1 GA Plan Level 00 - Ground Floor
1 : 100

Client name	Amber Solutions for Care
Project	Townlands Community Hospital, Henley
Drawing	Level 00 - Proposed Ground Floor Plan - Department Layout
Computer file	27711\2014 10:37:27
Project number	2011.01017.000
Scale	1 : 100
Issue status	INFORMATION

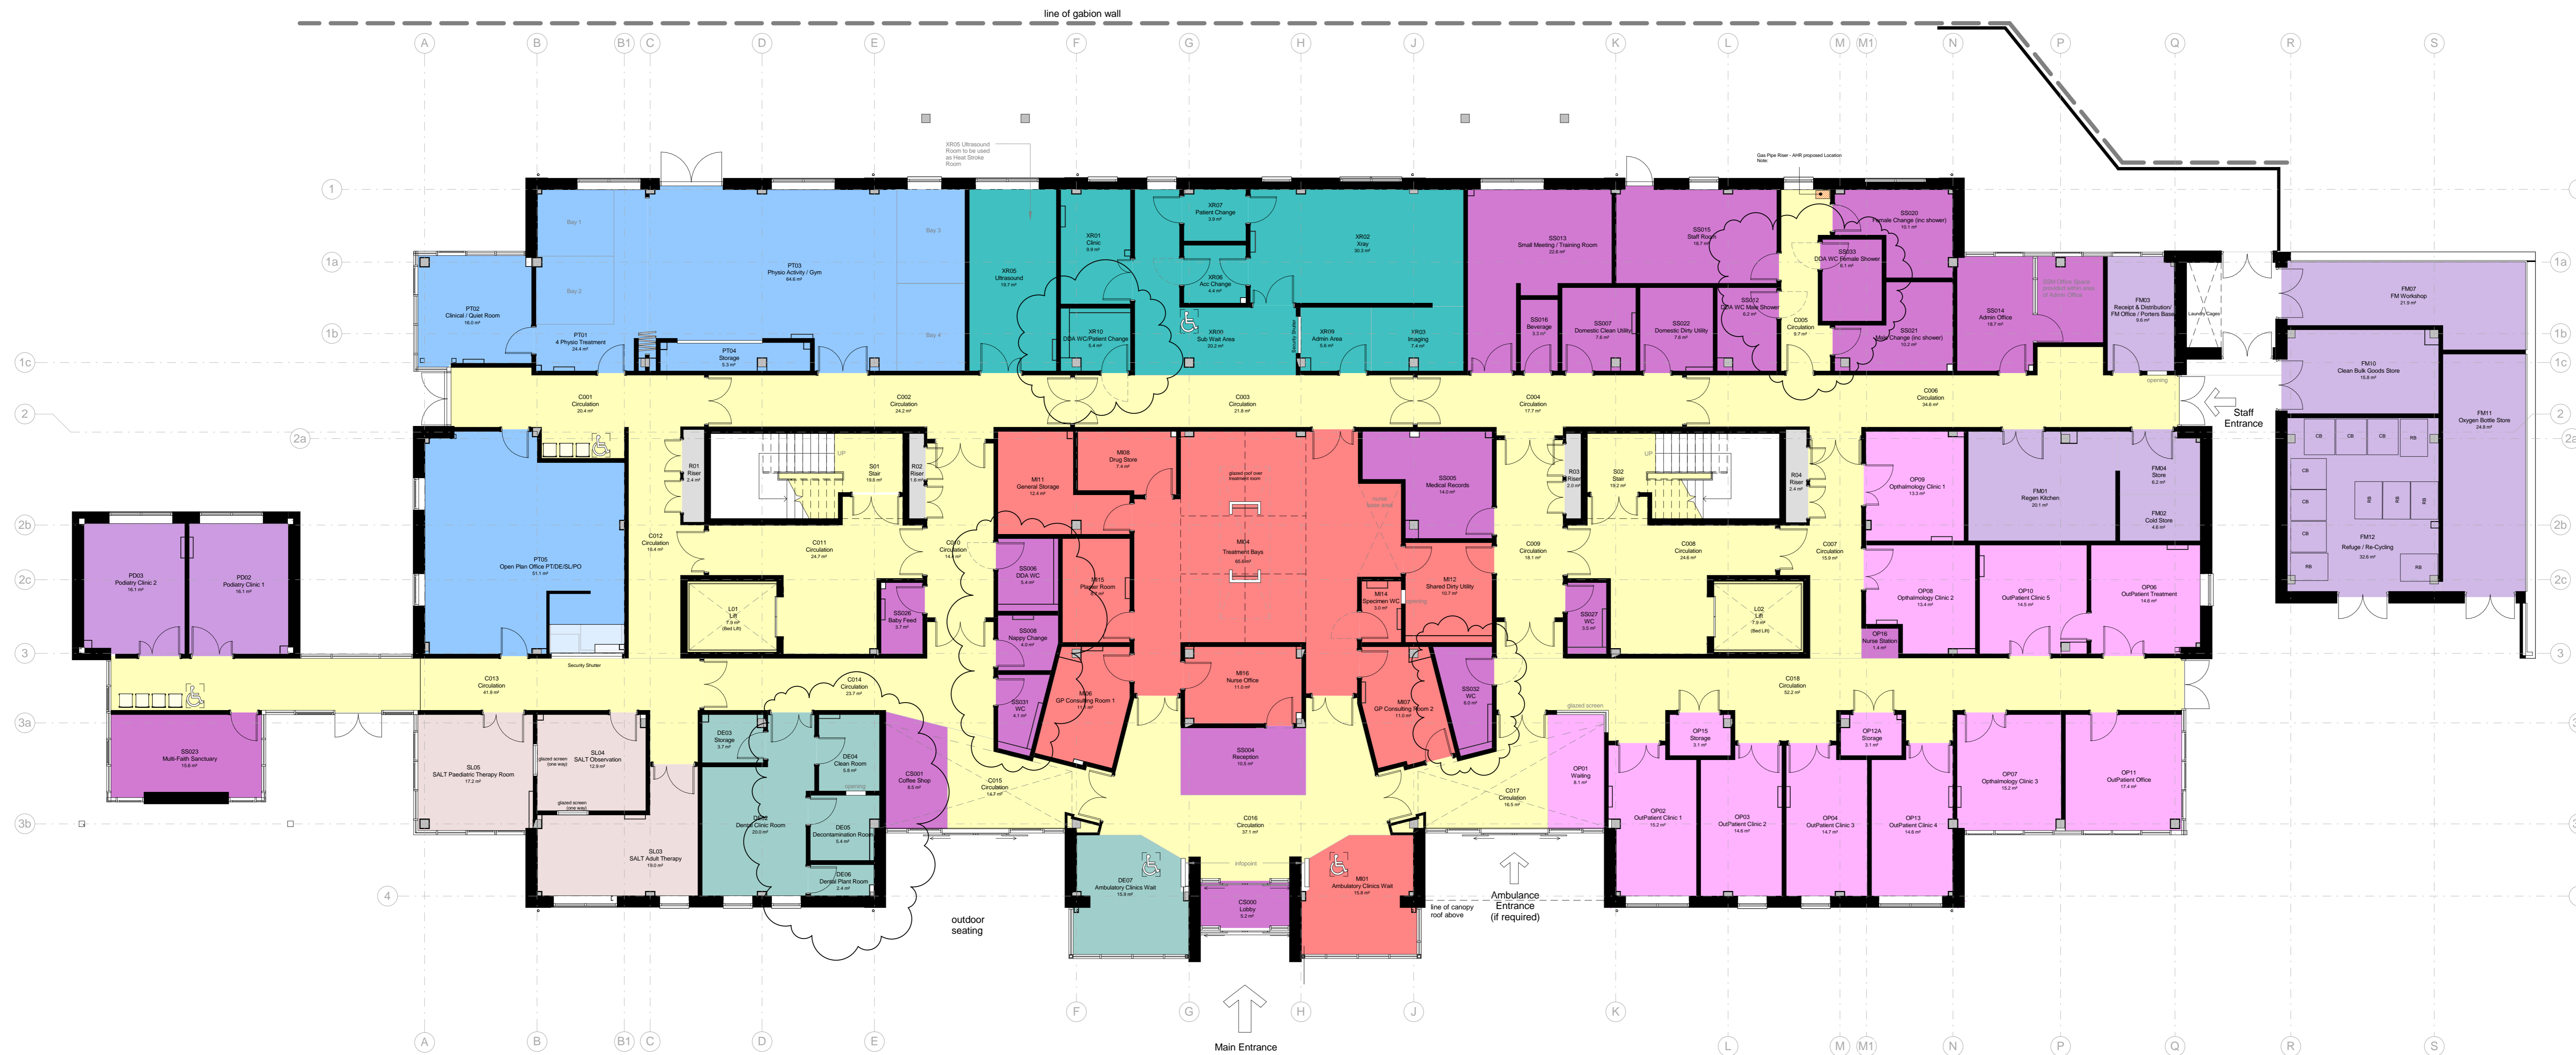
- Ground Floor amended to incorporate changes to dental layout. Trust requires Decontamination and Clean room facilities to be larger. We option to reduce space provided for Dental Plant rooms. Trust to confirm Layout.
- WC have been relabelled to meet Trust clarifications on types used throughout the scheme.
- Door to XR10 has relocated to open into circulation space.
